# ADDENDUM NO. 1

June 7, 2021

## Provo Peaks Elementary Re-Roof

# ADDENDUM NO. 1

**E1 OVERALL ROOF PLAN**  
A002 | SCALE: 1/16" = 1'-0"

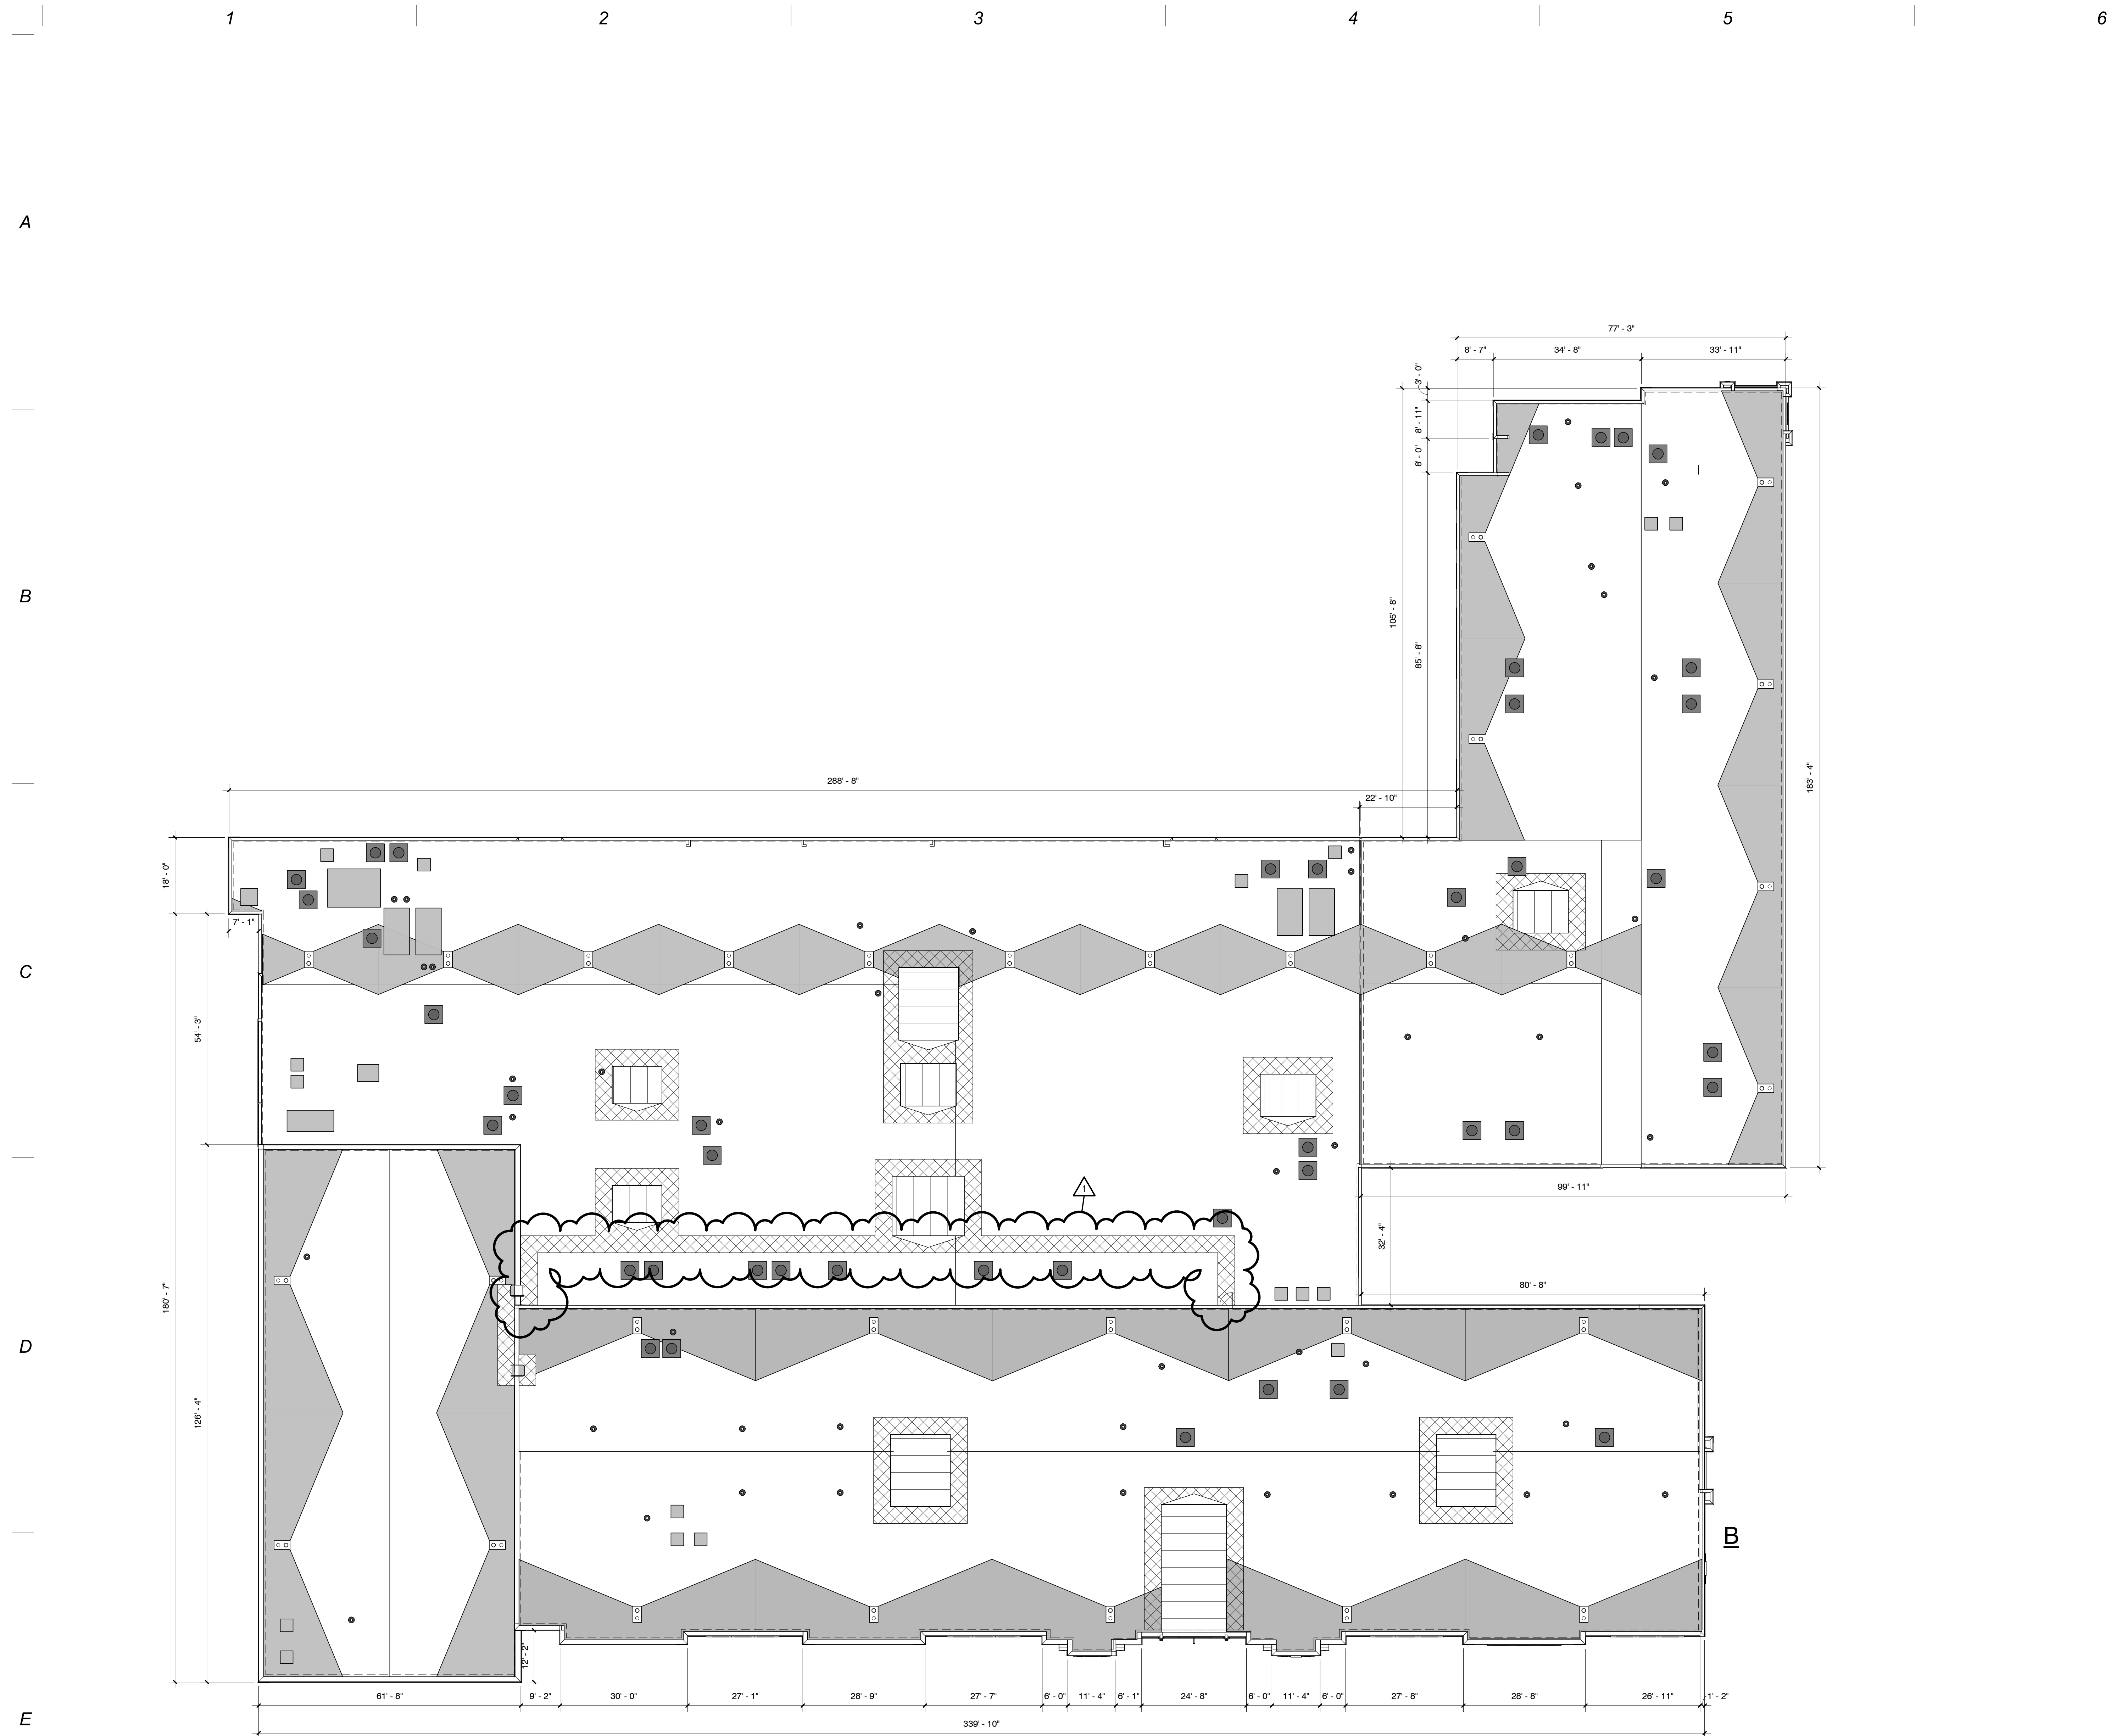
1. **Revised Bid Form** – See the attached revised bid Form
2. **Unit costs:** Per the attached revised Bid Form and Unit Prices Form the contractor shall provide a unit cost for all labor and materials associated with replacing damaged roofing insulation. If during construction the contractor discovers roofing insulation that is damaged and needs to be replaced the unit cost will be the basis for approving a change order.
3. **Sheet A004 added Sheet Note 1.28** – Provide turn bar half way up high parapet walls to prevent roofing membrane from pulling out from under parapet cap. See reference image E2/A007
4. **Protective Walkway** – See revised locations for protective walkway on revised sheets attached to this addendum.

- **Revised drawings with clouds: A002, A003, A004, A005**

MARK	REVISION	DATE
1	ADDENDUM #1	6/7/2021

**ALTERNATE #1** KEEP EXISTING FLASHINGS, DRIP EDGES, AND PARAPET CAPS AND REINSTALL.

**UNIT COST #1** PROVIDE UNIT PRICE FOR POLY-ISO INSULATION FOR INSTANCES WHERE EXISTING ROOF INSULATION NEEDS TO BE REPLACED

**E1** AREA 'A' ROOF PLAN  
A003 | SCALE: 1/8" = 1'-0"

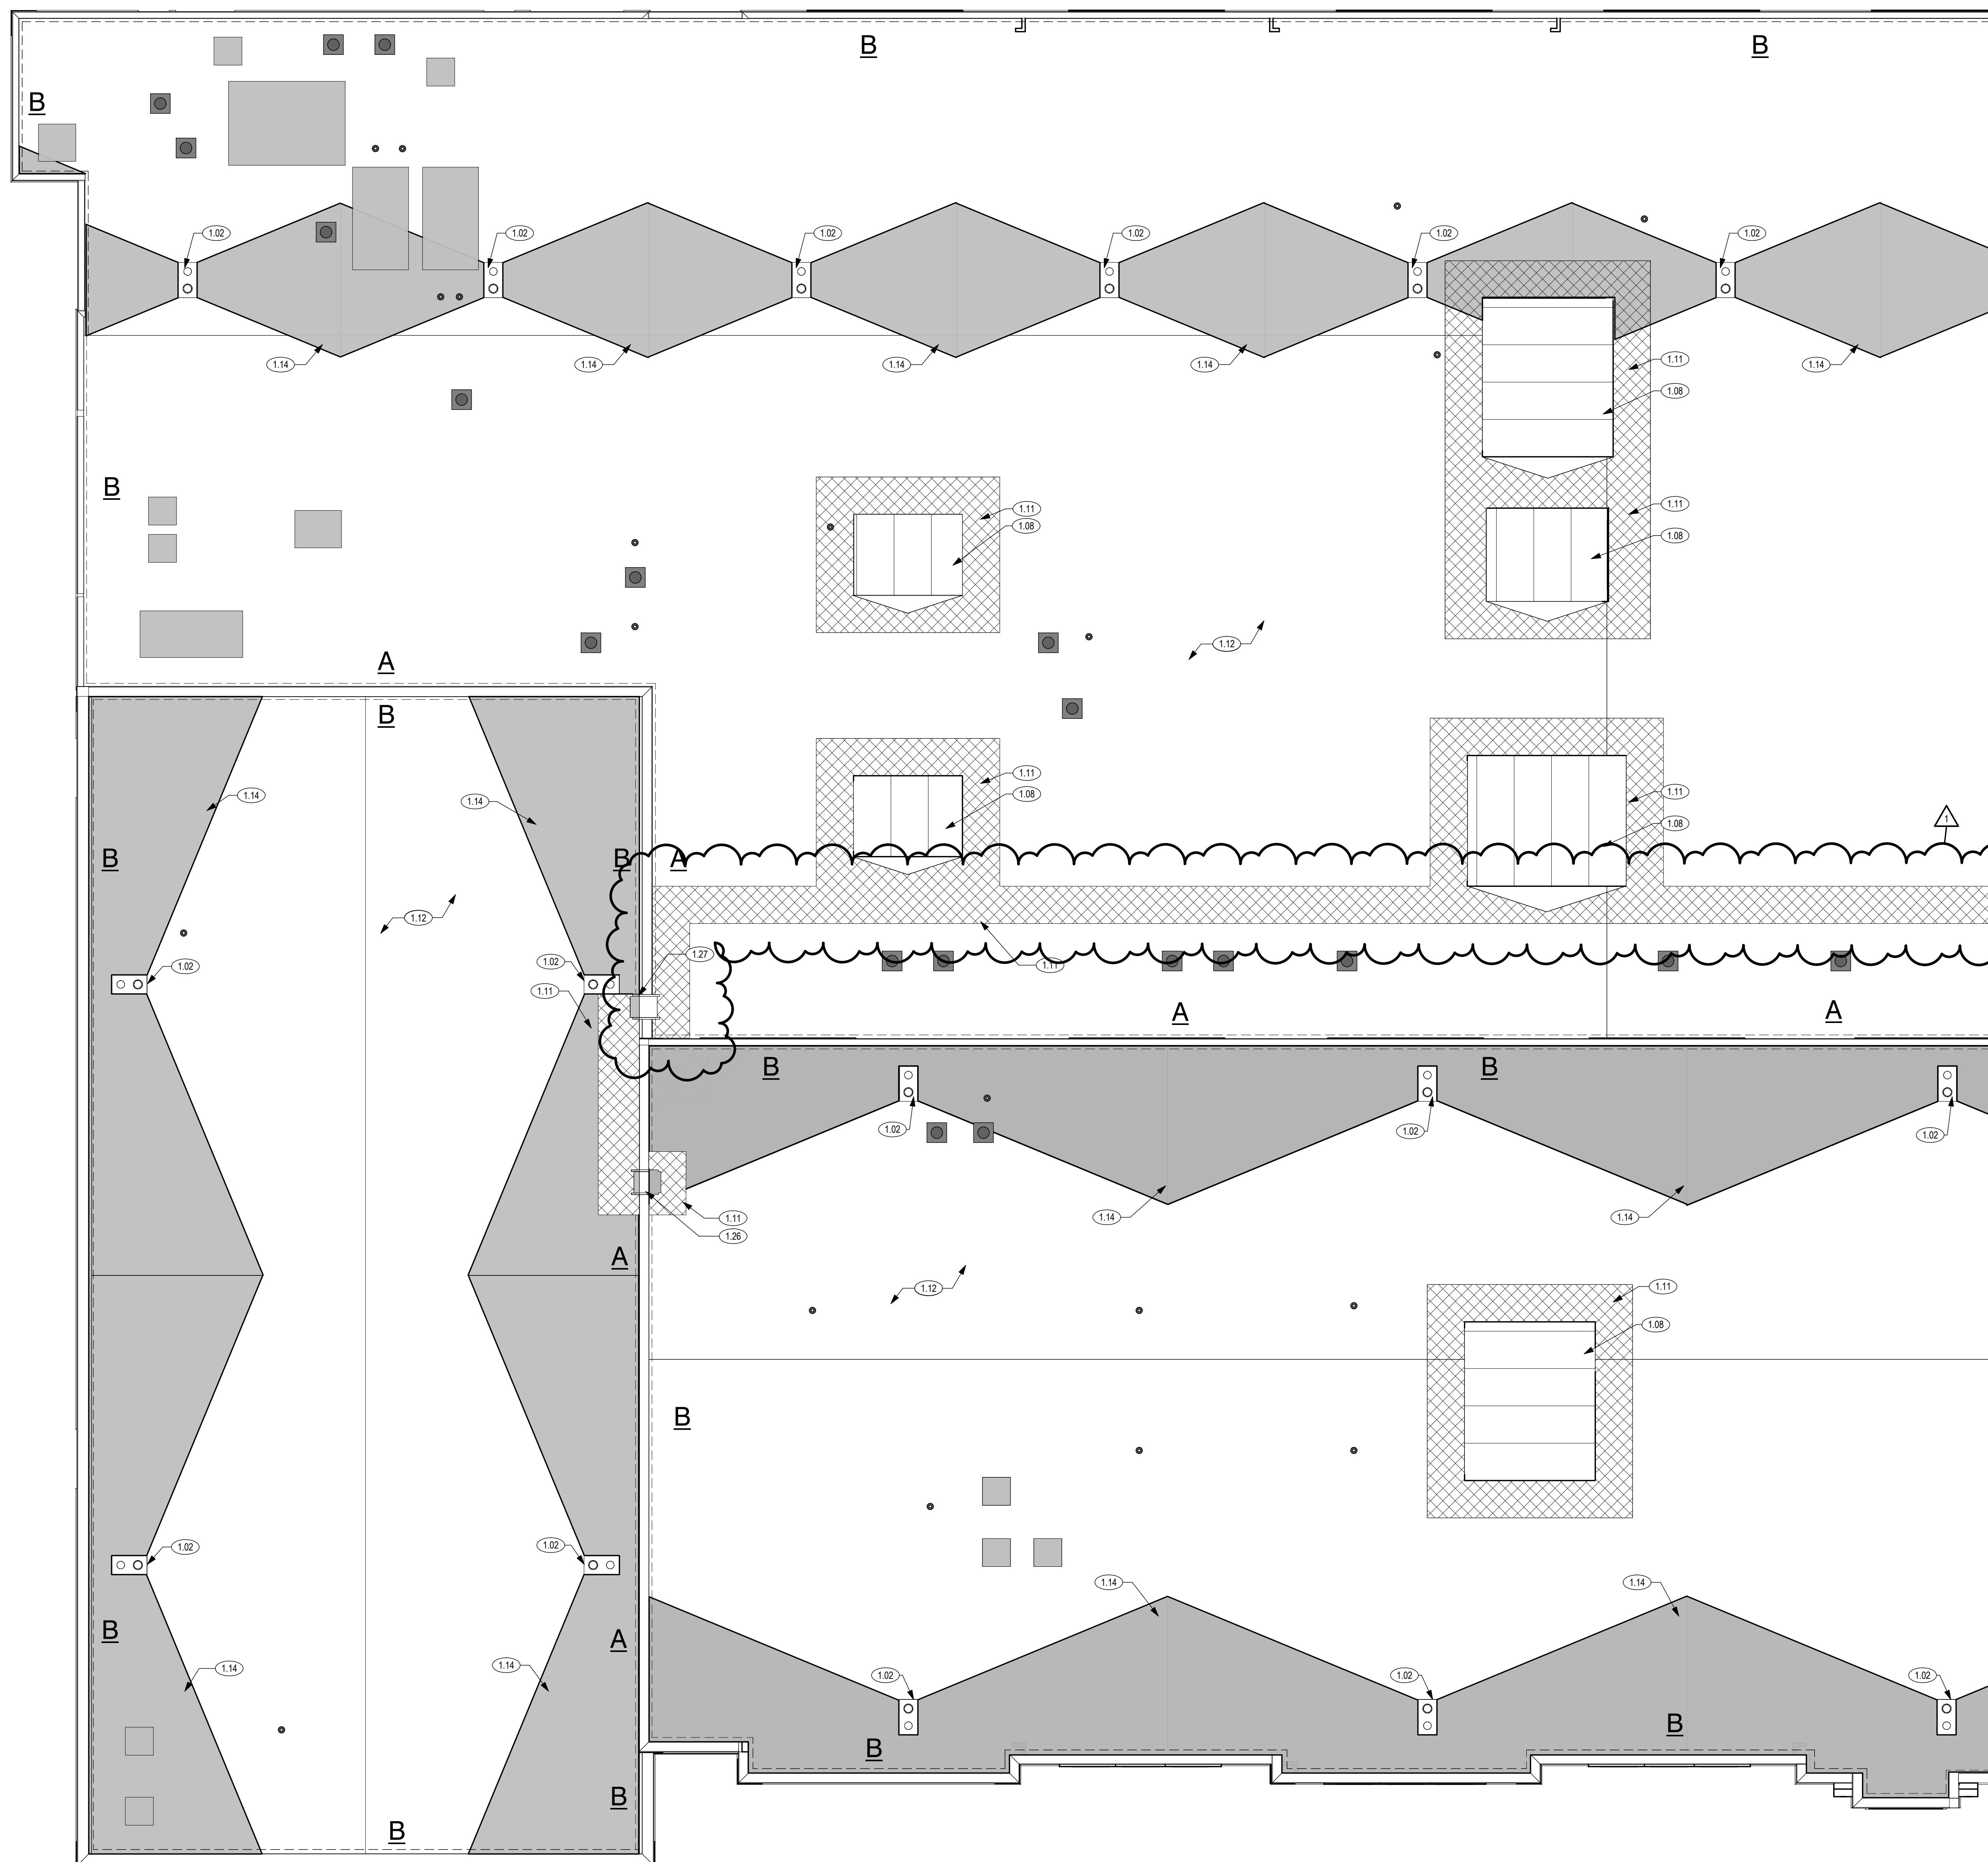
MARK	REVISION	DATE
1	ADDENDUM #1	6/7/2021

**ALTERNATE #1** KEEP EXISTING FLASHINGS, DRIP EDGES, AND PARAPET CAPS AND REINSTALL.

**UNIT COST #1** PROVIDE UNIT PRICE FOR POLY-ISO INSULATION FOR INSTANCES WHERE EXISTING ROOF INSULATION NEEDS TO BE REPLACED.
